Response to Referees' Comment on "Apsu: a wireless multichannel receiver system for surface-NMR groundwater investigations"

by Lichao Liu et al.

To referee R. Dlugosch (gi-2018-1-RC1):

Figure 1: An example of normalized amplitude of data recorded by the dual-gain channel of Apsu.

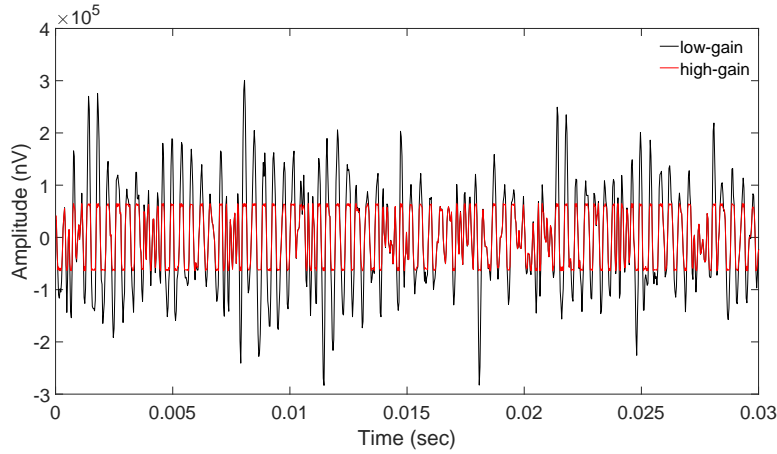
- The new feature of dual recording using two gain factors to reduce the chance of data clipping is well presented in the paper but the benefits are neither shown nor referenced.

Response: High-gain is beneficial to record to nano-voltage level NMR signal, especially the small coil is employed in our system. At the beginning of one measurement, the gain factor is configured but the noise level could increase later. In this case, the high-gain channel may be saturated but the low-gain channel is still usable, shown in [Figure 1](#). The recorded signals with amplitude lower than the limit of high-gain channel are identical but inly the data recorded by the low-gain channel is usable when the signal amplitude exceed the limit of high-gain channel. There are already four performance verification results are presented, hence this figure is not shown.

Figure 2: Recordings by two receiver boxes with a distance of 250 m. Four spikes are presented in both of the coils at the same time.

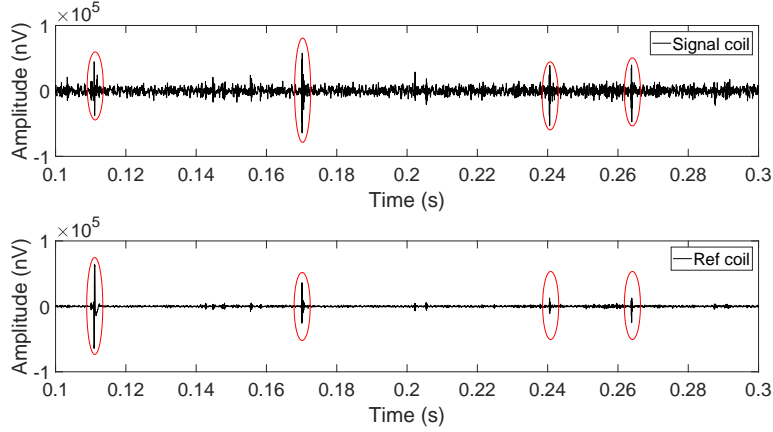
- a) is the timing i.e. synchronization jitter between the units, small enough to use RNC? → seems perfectly fine

Response:The jitter is determined by the GPS and is approximately 20 ns which is way more accurate than what is needed. The recordings from two receiver box with a distance of 250 m away are shown in Figure 2. We can find four spikes in signal coil and Ref coil happened at the same time stamp and have the same duration which confirm the two wireless channel is synchronous with ignorable jitter.
